ORIGINATION FORM

Proposed Revisions to a Standard Plans Index
(Please provide all information — Incomplete forms will be returned)

Index Number: 102-602
Sheet Number (s): 1 and 2 of 2
Index Title: Two-Lane and Multilane, Work on Shoulder

TWO-LANE AND MULTILANE, WORK ON SHOULDER

SHEET
1 of 2

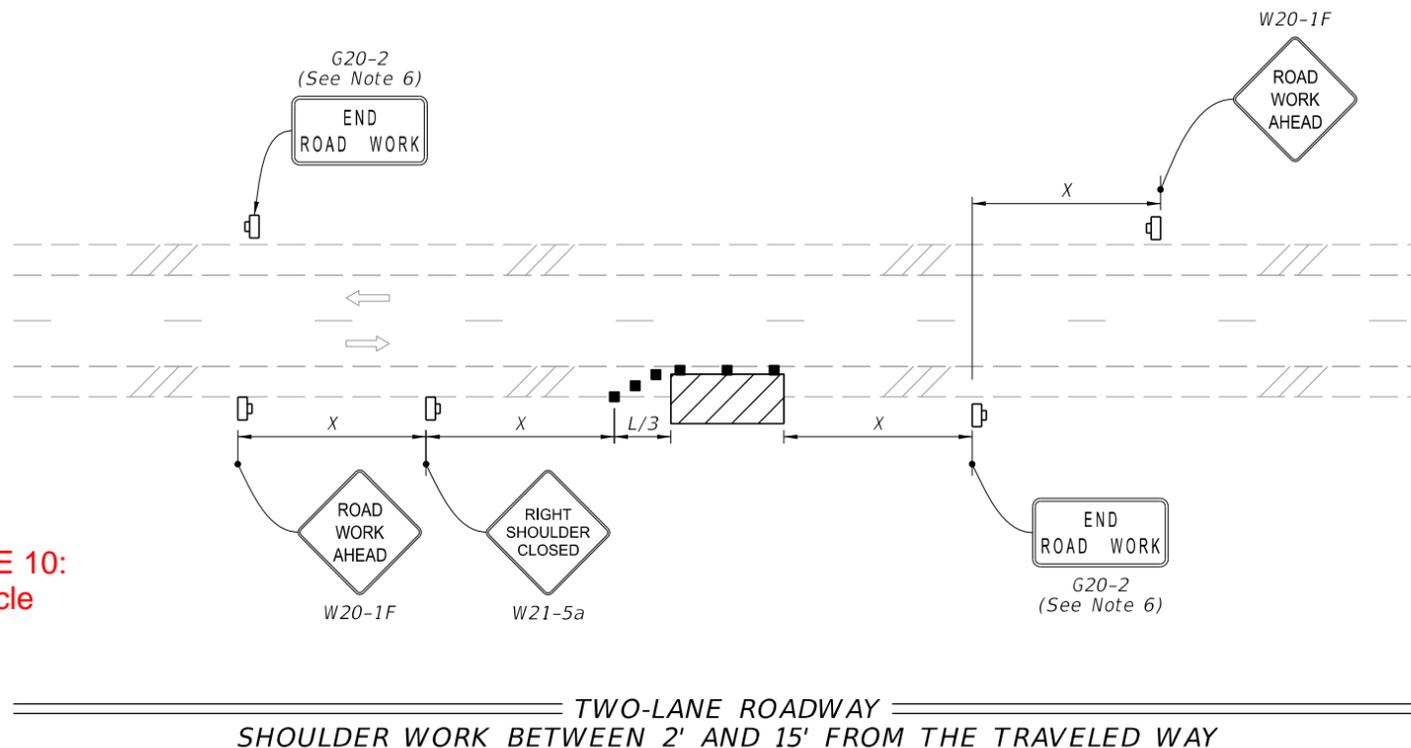
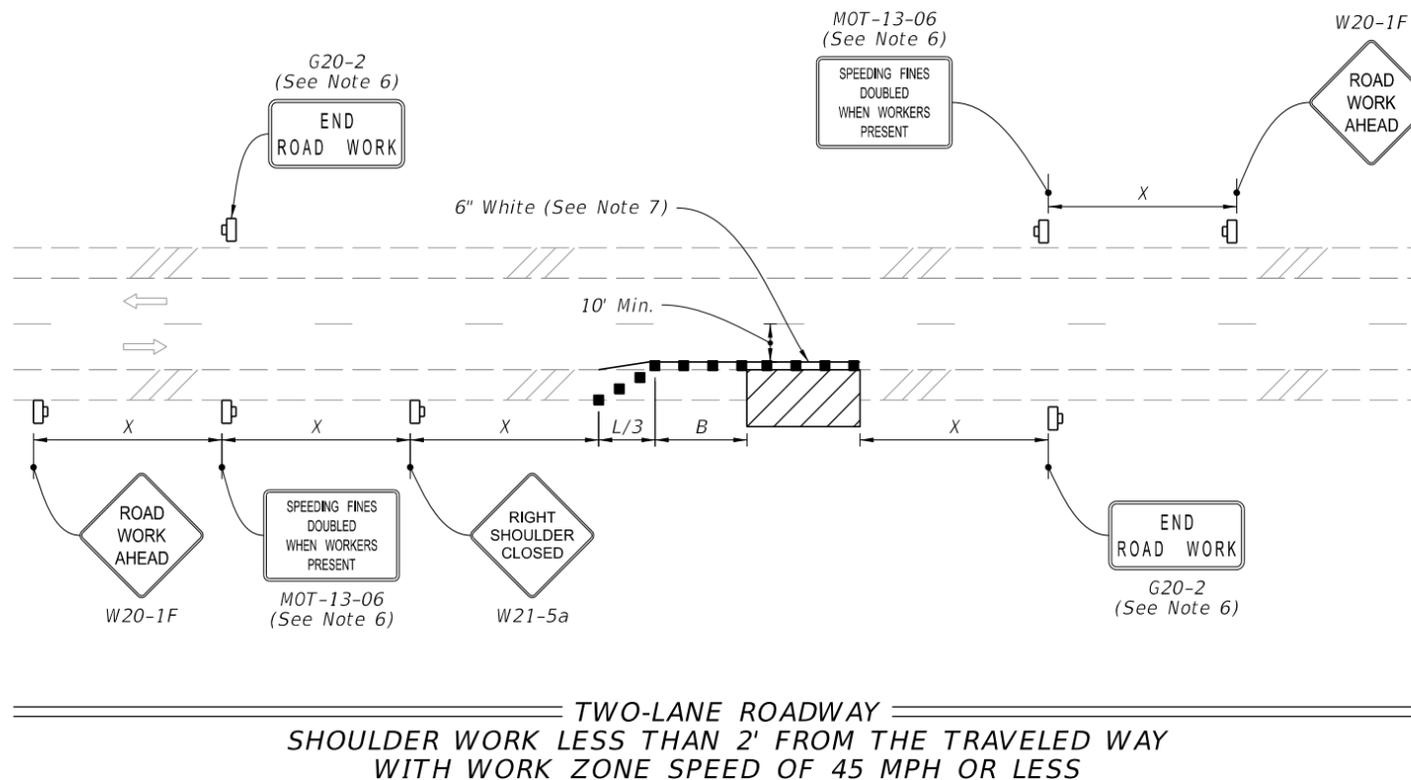
Sheet 1: Changed "Notes" To "General Notes"; Added General Note 10 "Shadow Vehicle required..."

ADDED NOTE 10:
Shadow Vehicle required...

9. When there is no paved shoulder, the "Worker" sign (W21-1) may be used instead of the "Shoulder Closed" sign (W21-5a).
10. A shadow vehicle is required for multilane roadways with a work zone speed greater than 45 MPH. The Engineer may omit the shadow vehicle where it is not feasible.

MULTILANE ROADWAY
 SHOULDER WORK BETWEEN 2' AND 15' FROM THE TRAVELED WAY

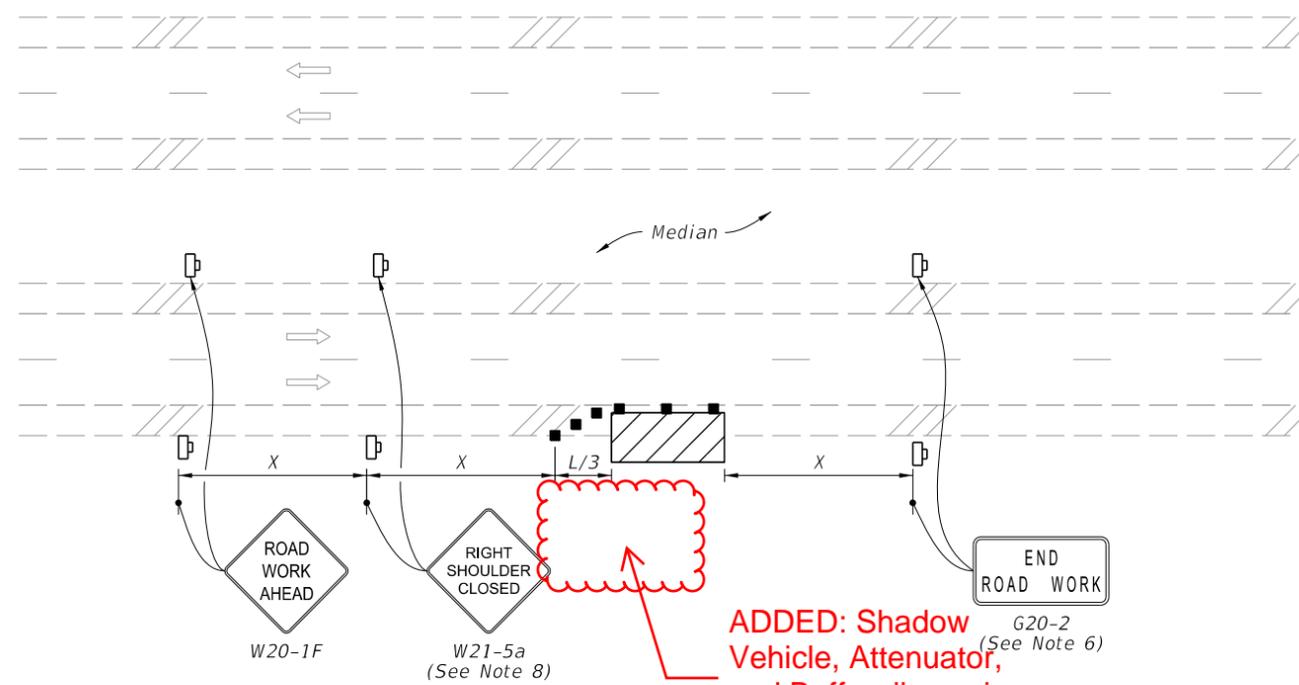
Sheet 2: Added Shadow Vehicle, Attenuator and Buffer dimension to the MULTILANE ROADWAY -SHOULDER WORK BETWEEN 2' AND 15' FROM THE TRAVELED WAY detail; Added the Shadow Vehicle and Attenuator to the Symbols

ADDED: Shadow Vehicle, Attenuator, and Buffer dimension

Shadow vehicles were added to the high-speed details for TMAs to be included in the TTCP. A new note was added for the Engineer to omit the TMA if it is not feasible to have one in the site specific work zone.
